SUNDRY NOTICES AND REPORTS ON WELLS

8. Well Name and No.
MARQUARDT 1 PENN FED 2

9. API Well No.
30-015-34194-00-S1

Marquardt 1 Penn Federal #2

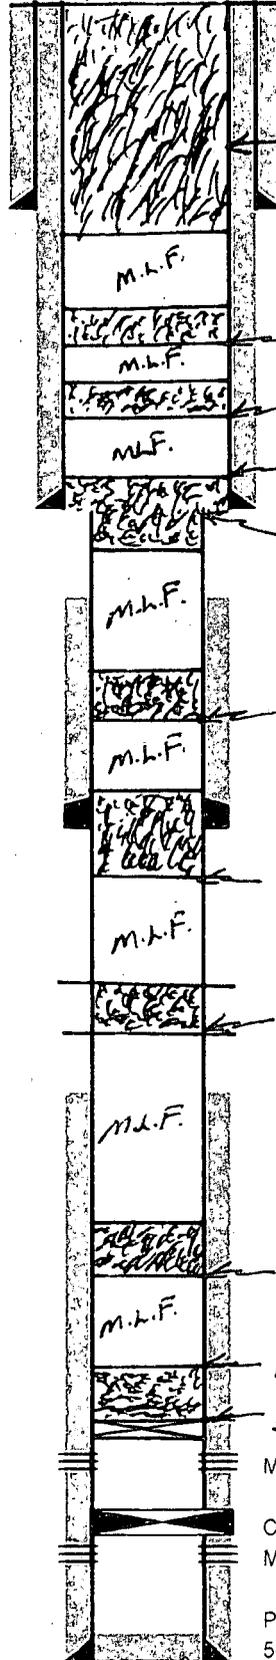
CIRC. 100 SXS @ 263'-3''

Pump 45 SXS @ 850'-750'-TAG

Pump 45 SXS @ 1,555'-1,445'

Pump 55 SXS @ 3,265'-3,125'-TAG

Pump 25 SXS @ 6,248'-6,088'

Pump 25 SXS @ 7,558'-7,388'-TAG

PERF. X SQZ. 45 SXS @ 8,728'-8,543'

Pump 35 SXS @ 10,483'-10,202'

Pump 25 SXS @ 11,100'-10,900'

SET 5 1/2" CIBP @ 11,100'
